**PB# 05-13**

**Shady Dell  
(Sub.)**

**TOWN OF NEW WINDSOR  
PLANNING BOARD  
REVIEW COMMENTS**

**PROJECT NAME:** SHADY DELL (BUCK) MAJOR SUBDIVISION  
**PROJECT LOCATION:** OFF MT. AIRY ROAD  
SECTION 65 - BLOCK 1 - LOT 83.2  
**PROJECT NUMBER:** 05-13  
**DATE:** 9 NOVEMBER 2005  
**DESCRIPTION:** THE APPLICATION PROPOSES THE SUBDIVISION OF THE 22.2 +/- ACRE PARCEL INTO FIVE (5) SINGLE-FAMILY RESIDENTIAL LOTS. THE PLAN WAS PREVIOUSLY REVIEWED AT THE 11 MAY 2005, 24 AUGUST 2005, 14 SEPTEMBER 2005 AND 28 SEPTEMBER 2005 PLANNING BOARD MEETINGS. THE APPLICATION IS BEFORE THE BOARD FOR A PUBLIC HEARING AT THIS MEETING.

ENLARGED FROSION CONTROL/ SWPPP PLAN  
SCALE: 1" = 50'

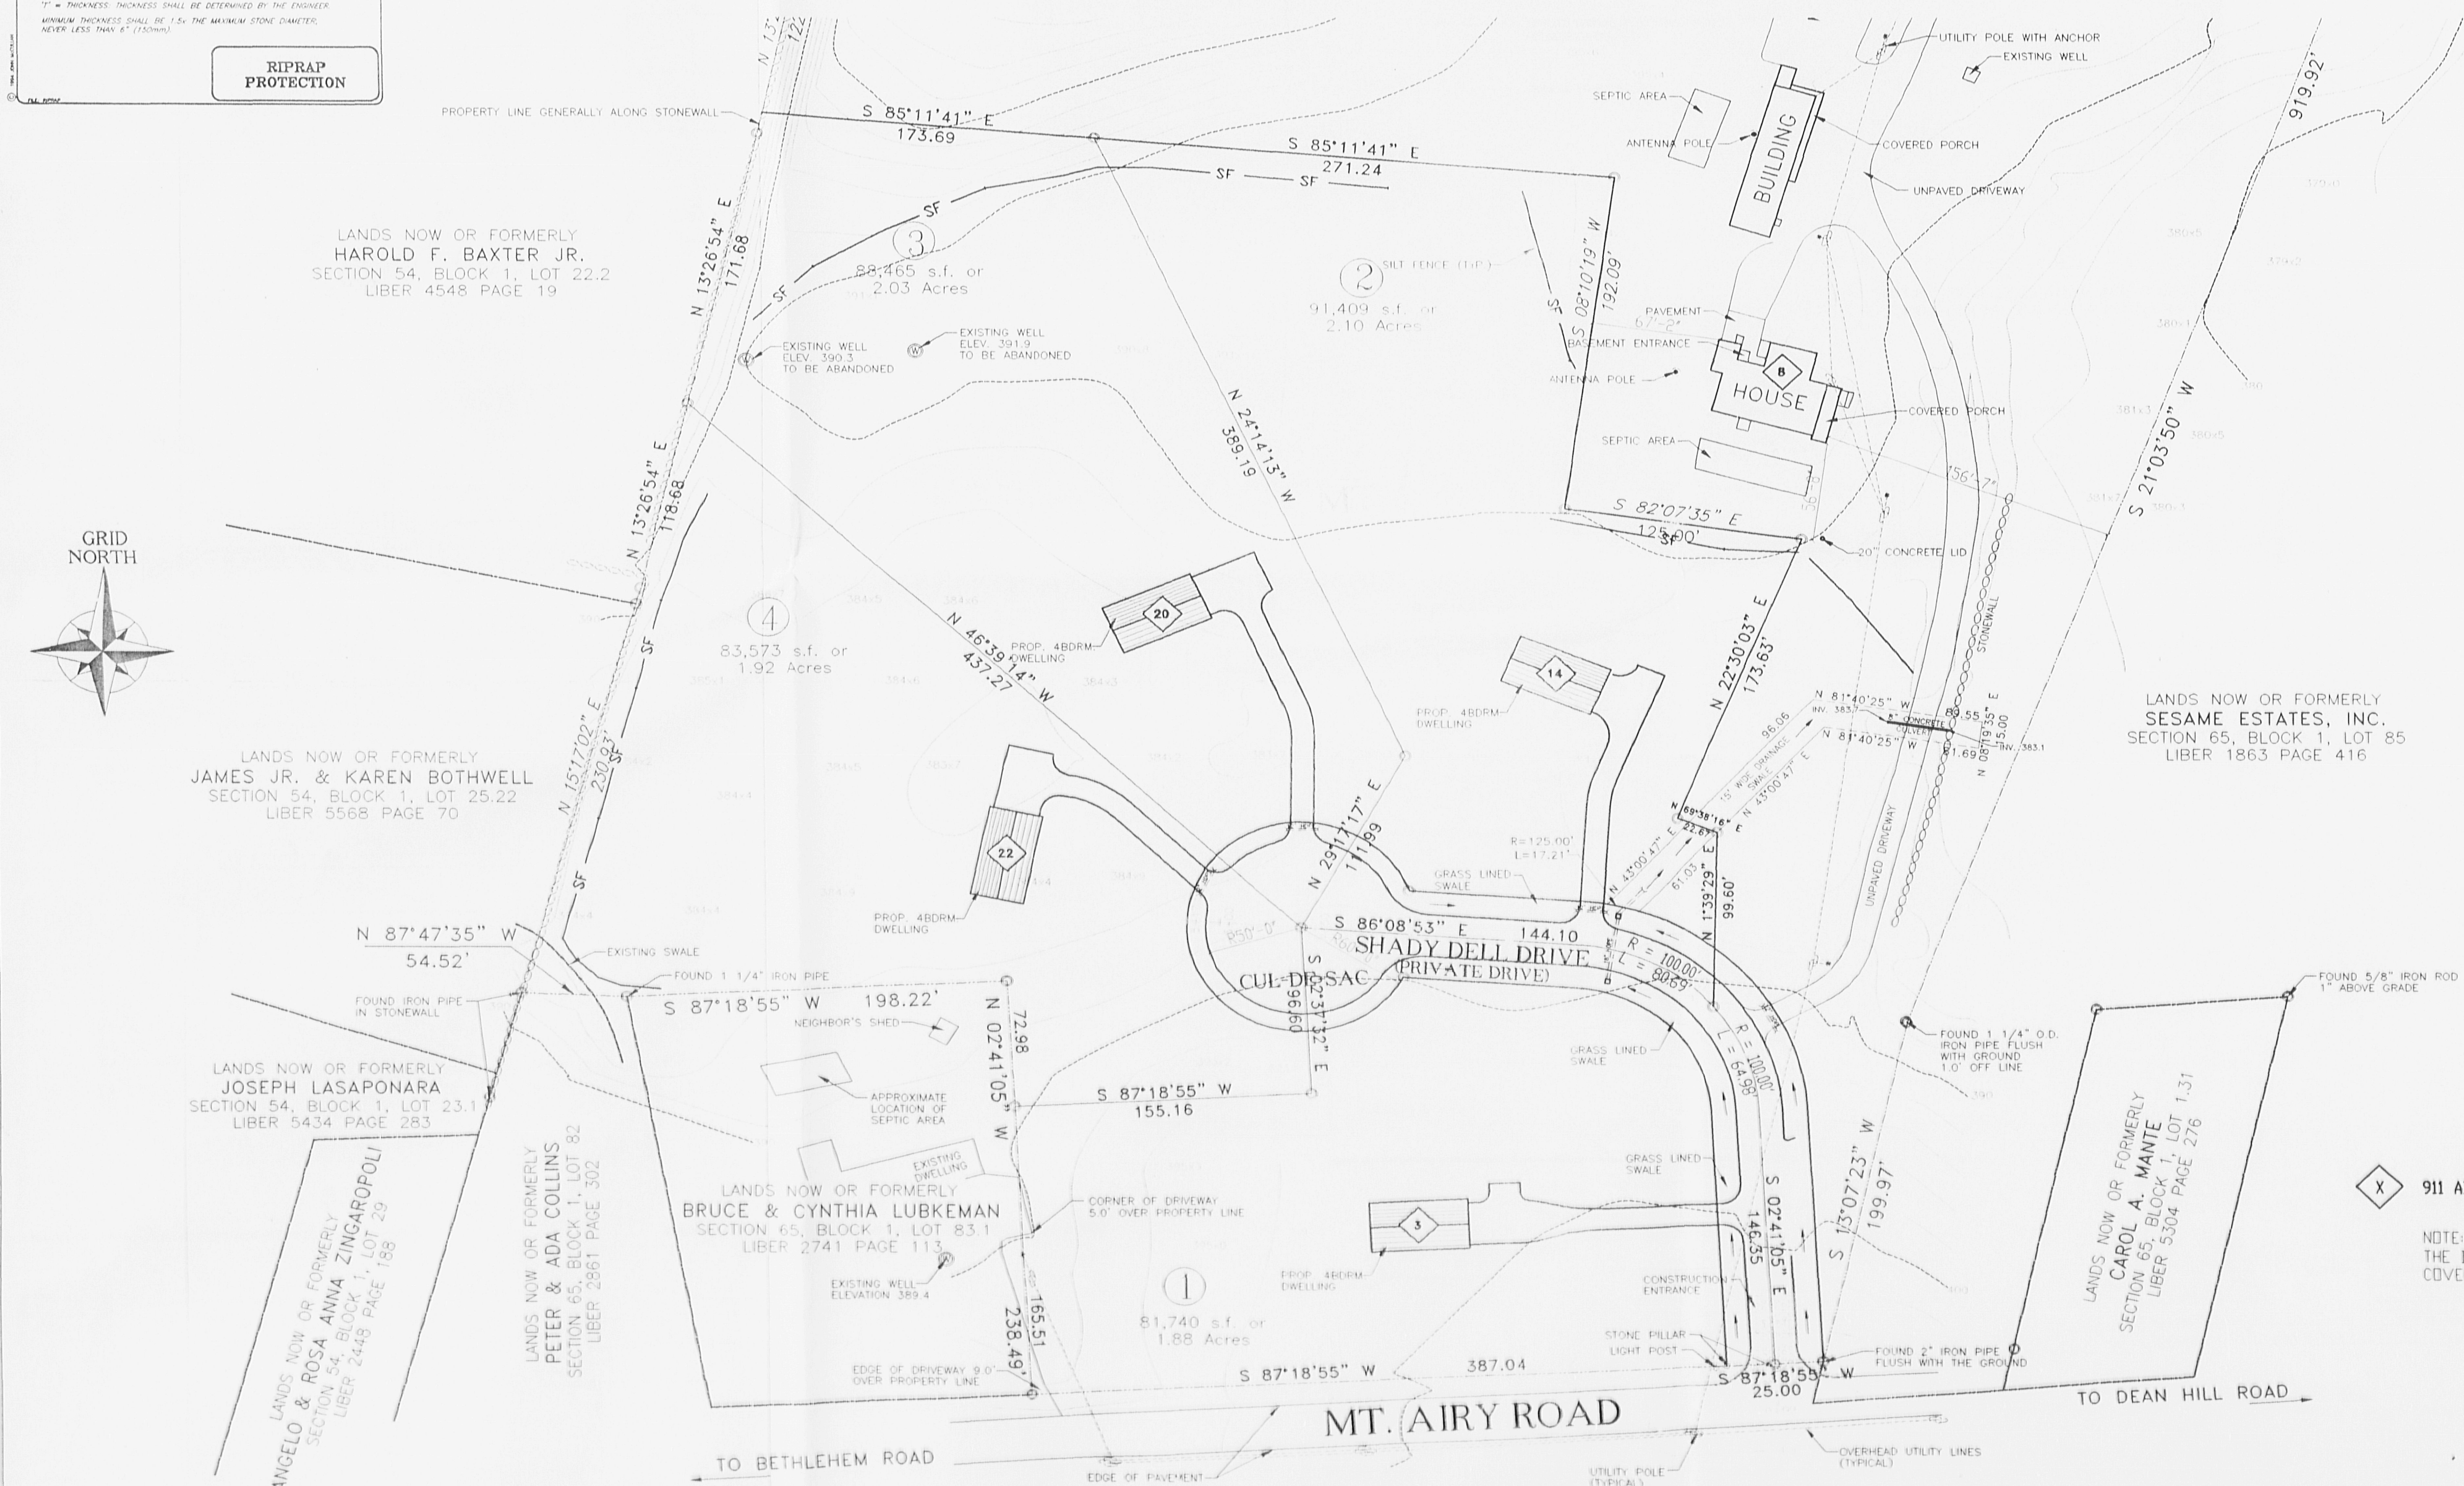
- Plan should more clearly depict property lines and easement lines. (correct drafting pen "weight")
- A private road profile and construction detail should be provided.
- Stormwater provisions should be indicated for the private road.
- A Soil Erosion & Sediment Control plan should be prepared .
- A SWPPP should be submitted.

As previously noted, all requested corrections to the plans have been made. In addition, our office has reviewed the SWPPP submitted and takes no exception. We have no outstanding comments.
